**CITY OF PORTLAND, MAINE**  
**PLANNING BOARD**

**RE: Mercy Hospital – Amendment to Approved Site Plan:  
Re-Use Of Existing Building for Maintenance and Storage Facility  
Vicinity of Fore River, Portland ME  
Application ID Number: 2008-0003; Chart 073, Block A, Lot 1001**

MERCY HOSPITAL - AMENDMENT TO APPROVED SITE PLAN

SHEET No.  
**LP101**

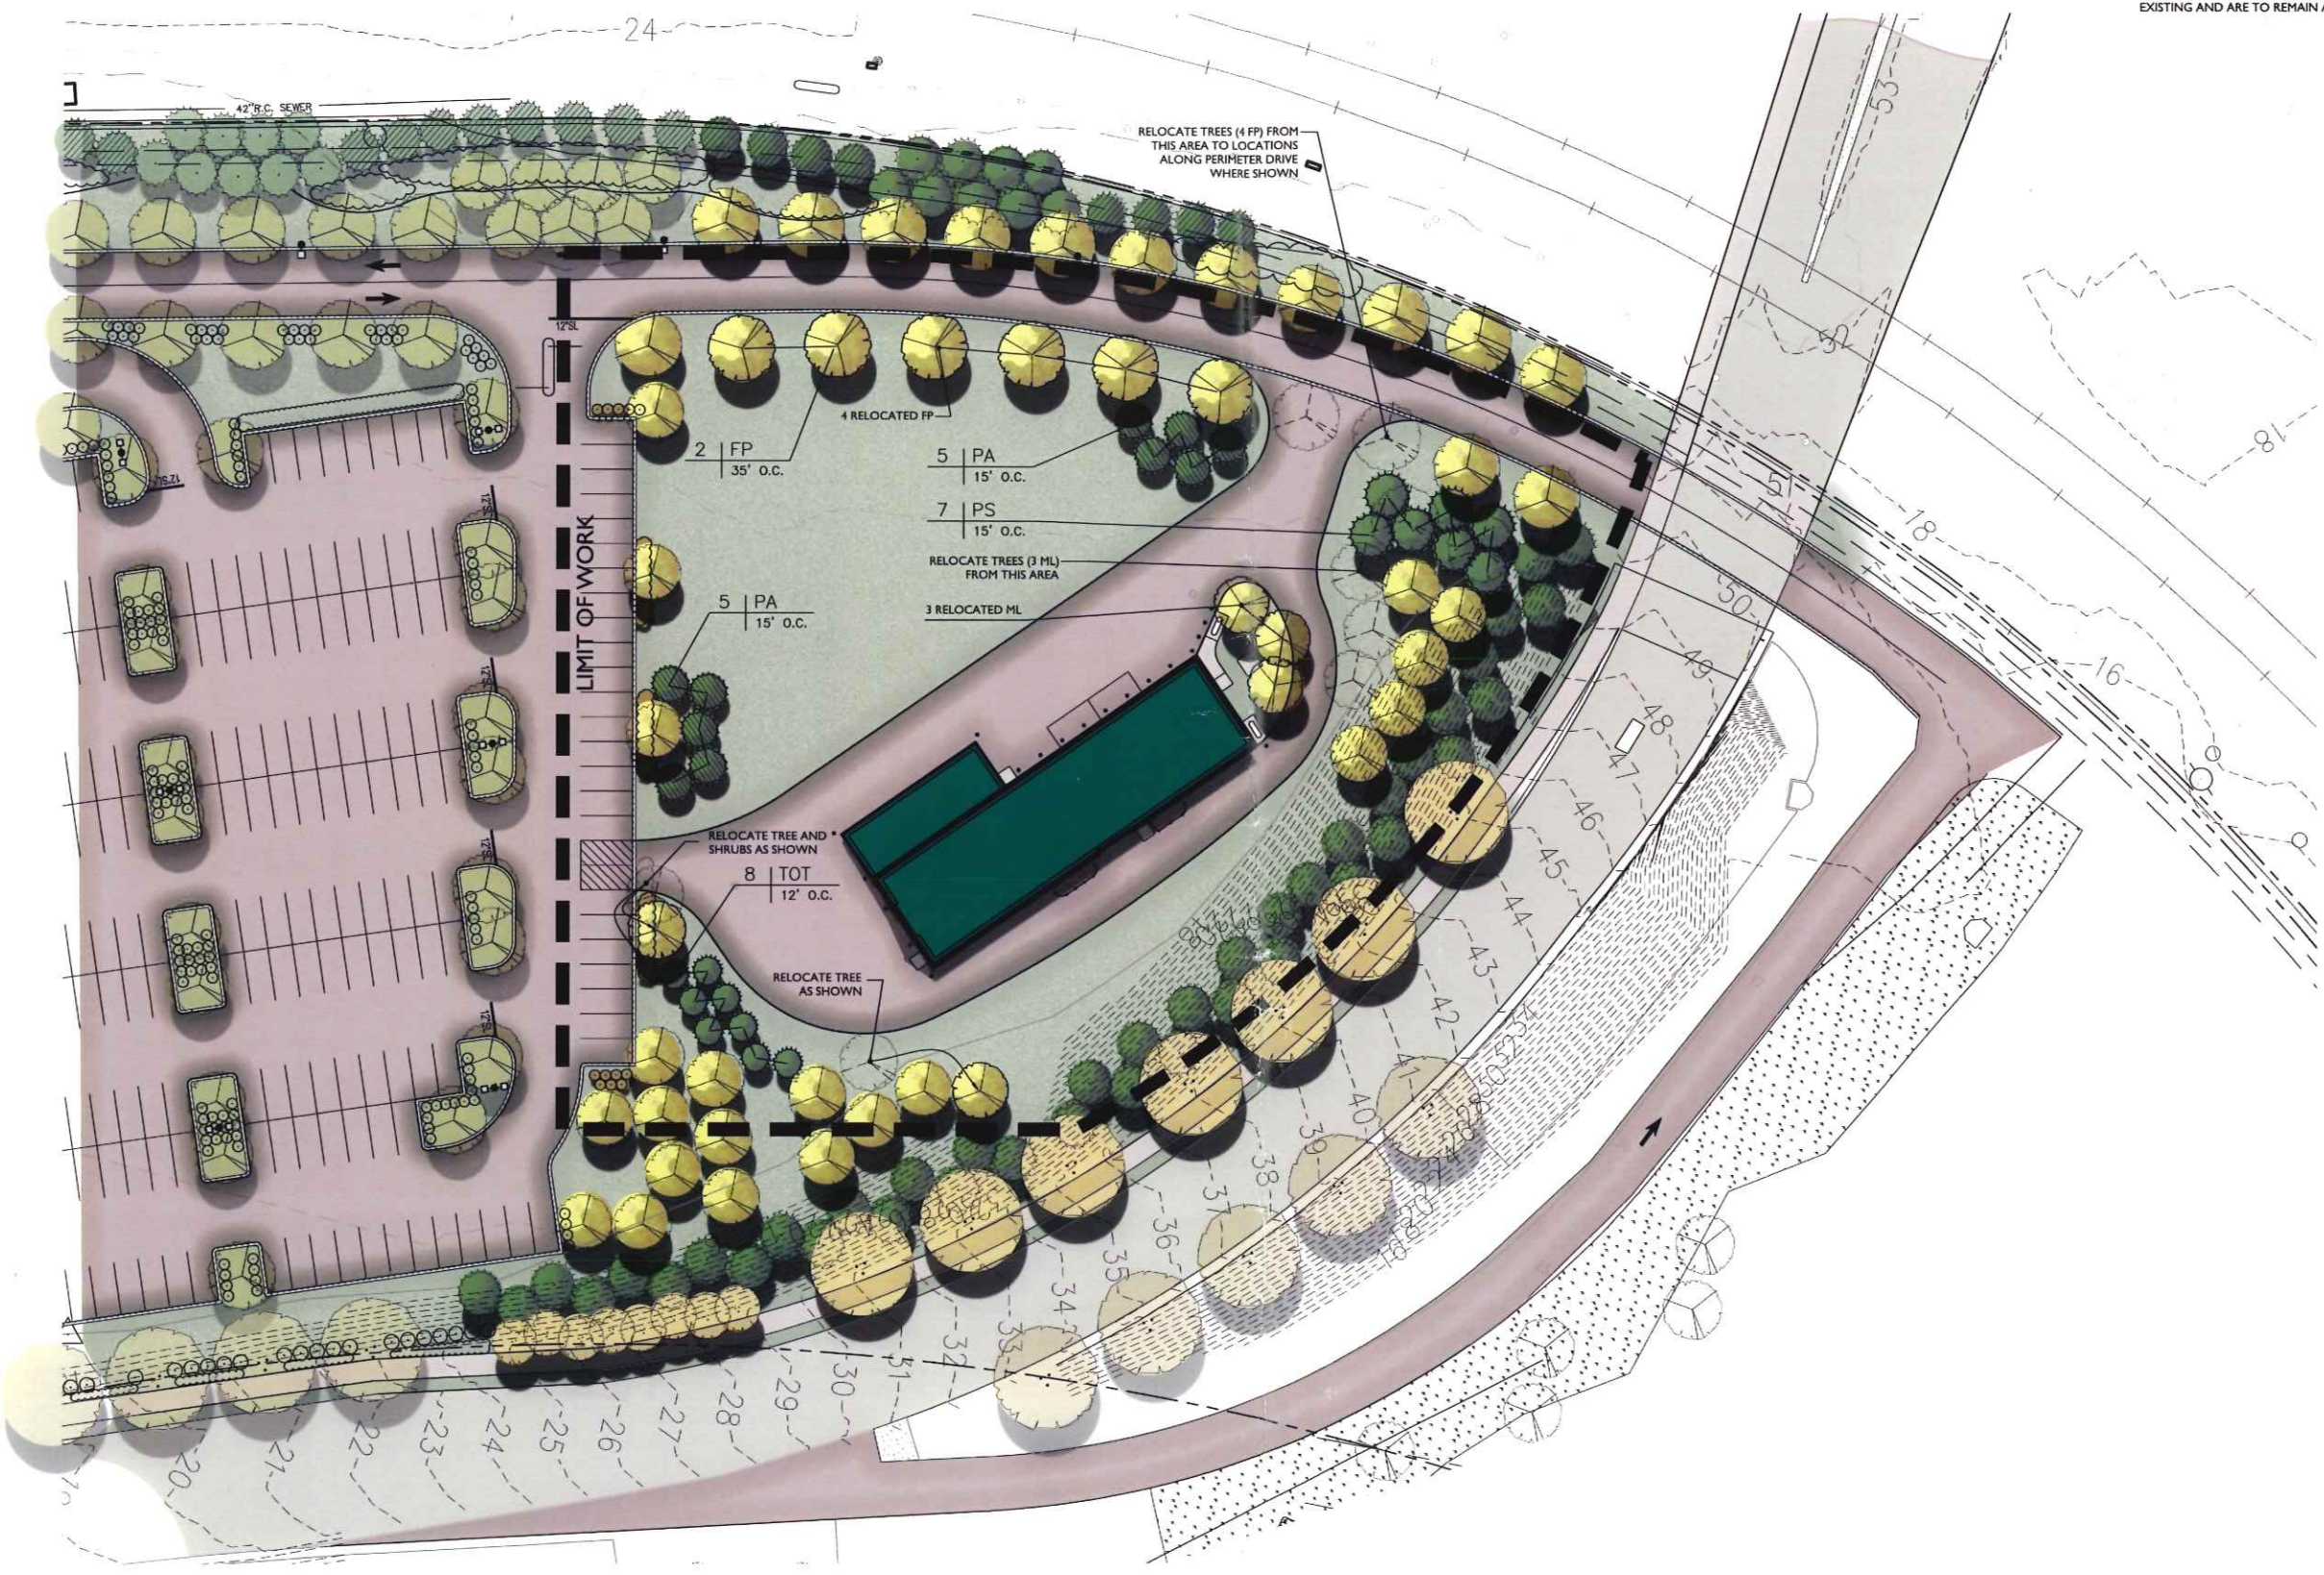
Staff had recommended that the landscape proposals included in the Workshop Memo be enhanced to improve screening of the building, given that the building architecture and associated tanks and equipment were functional and not attractive. The landscape proposals have been revised to include additional planting, as shown in Attachment 9i and 10a, and the City Arborist confirms these to be acceptable (Attachment 7b).

The revised landscape plan includes the items requested and is acceptable as shown.

SHEET No. **AE201**

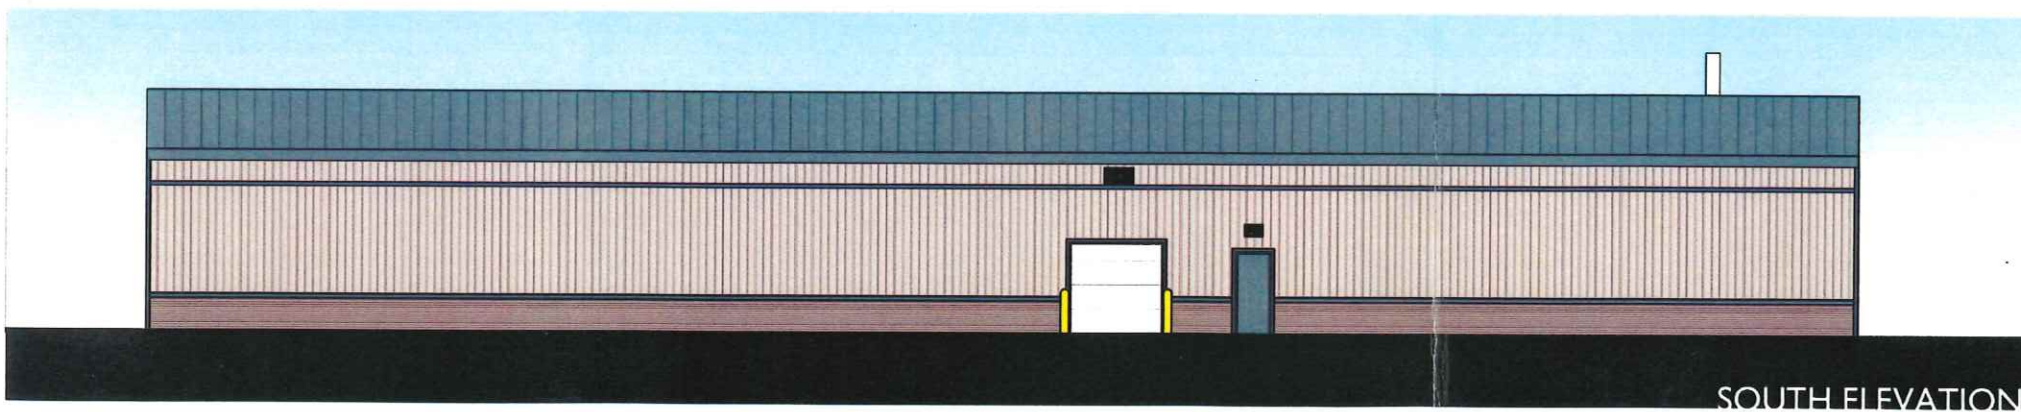
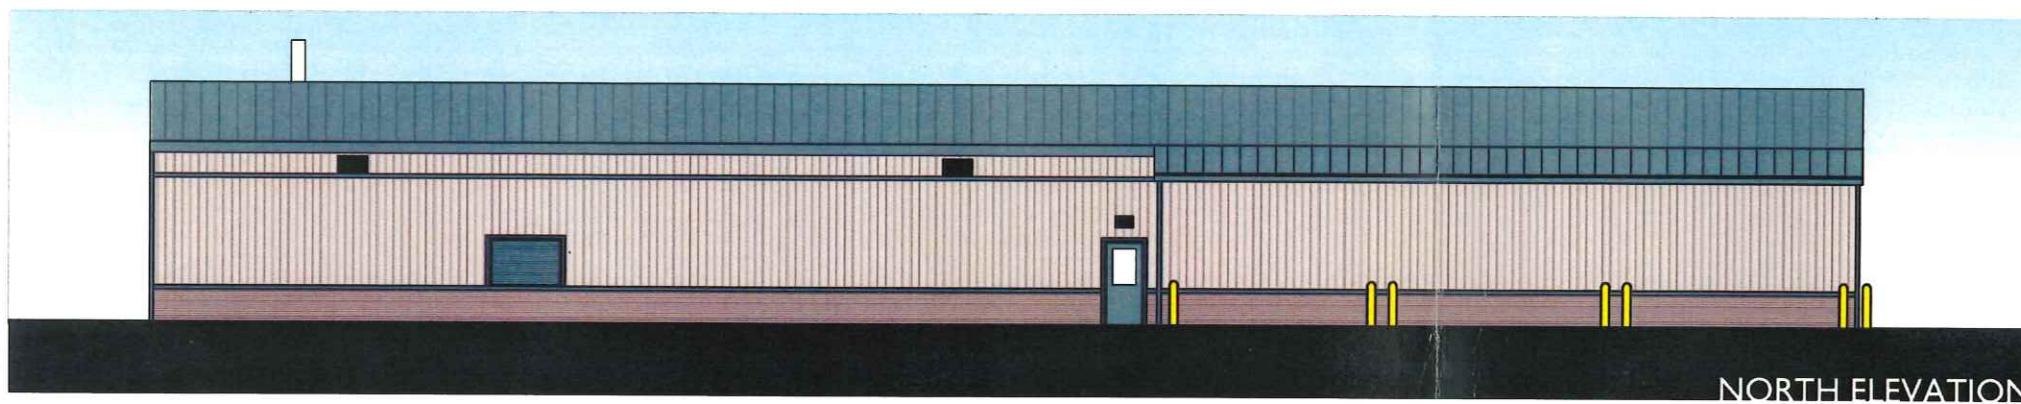
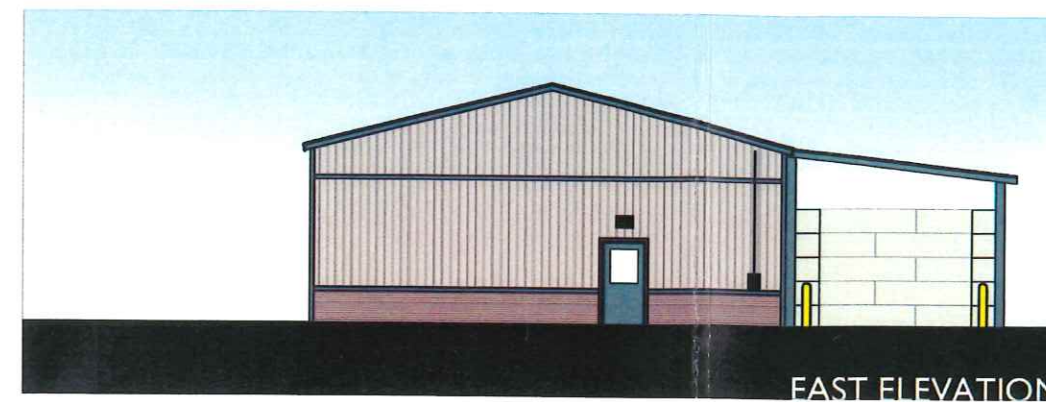
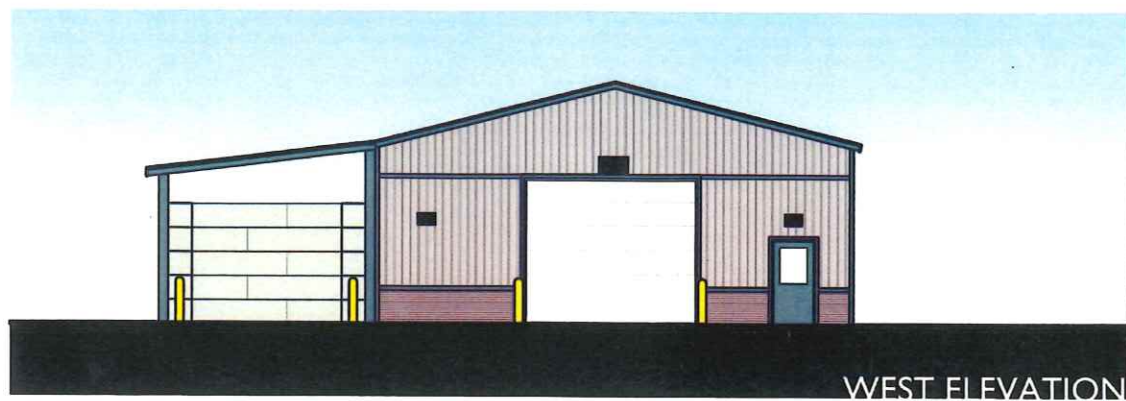
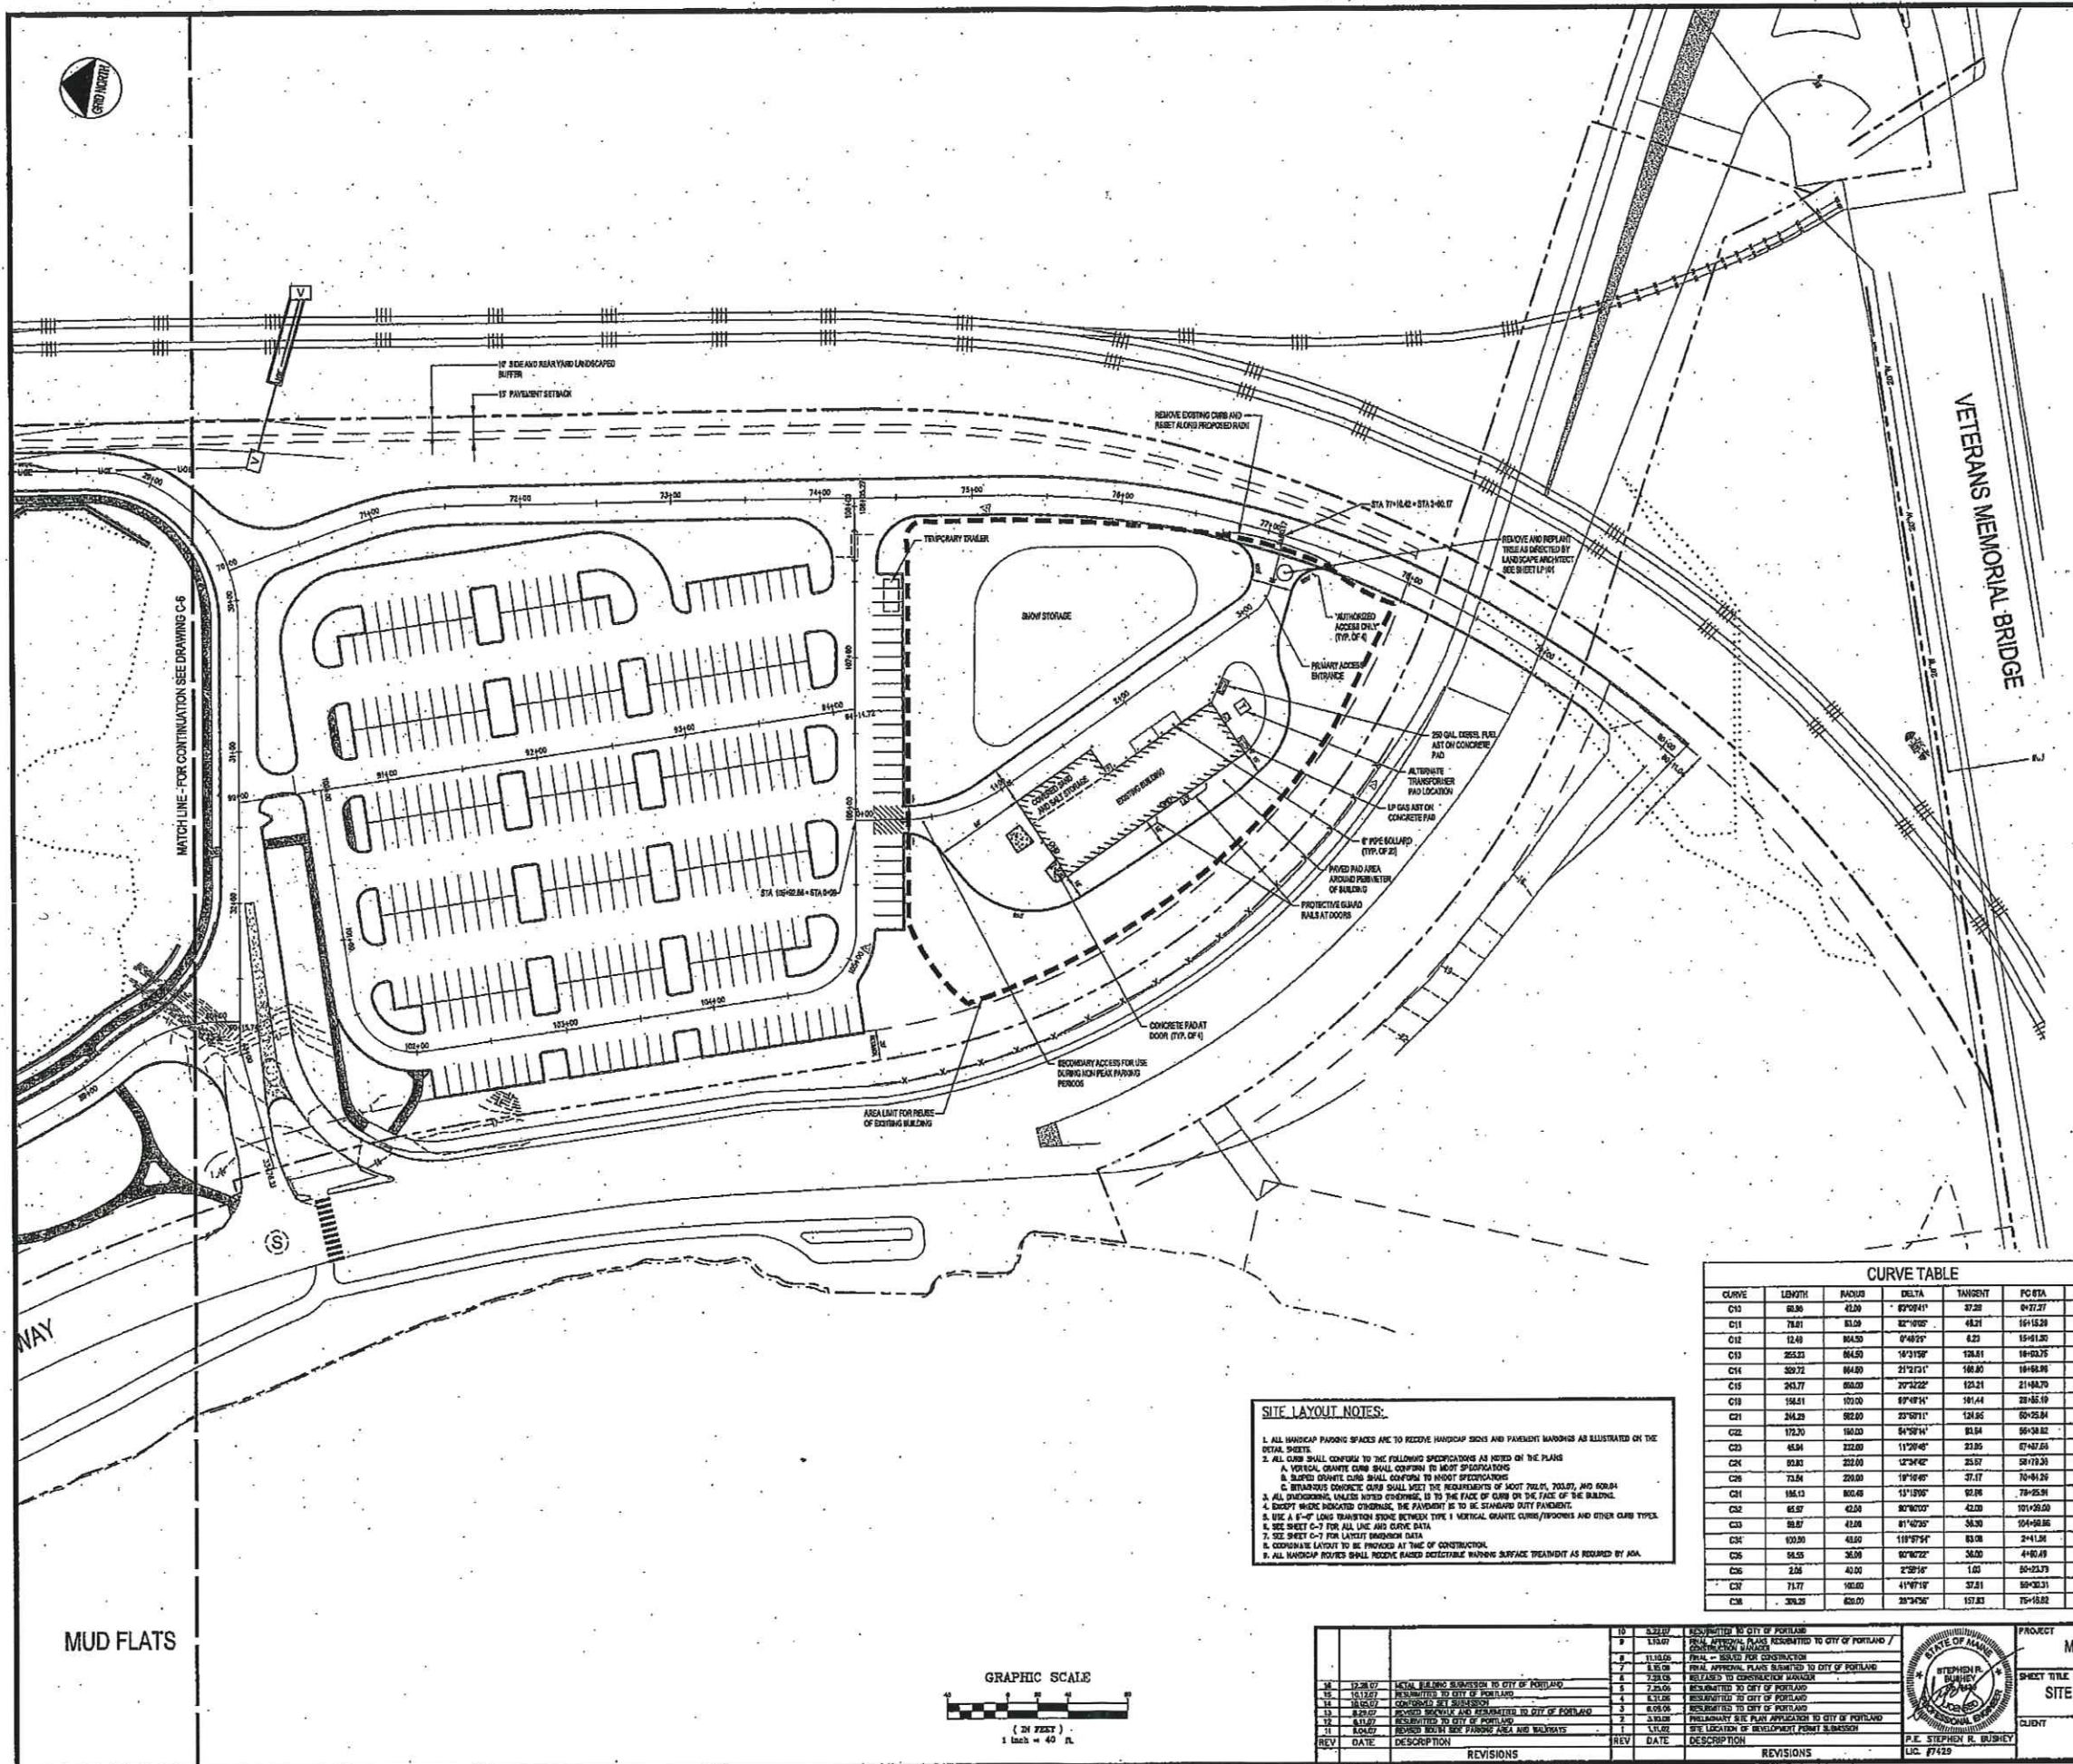
As long as the substitute material has the same characteristics (weathering, texture etc) and as long as the way the lengths are place on the building match AE201 (the approved external elevations) then we are OK with the color substitutions and this will be documented as a di minimus change.
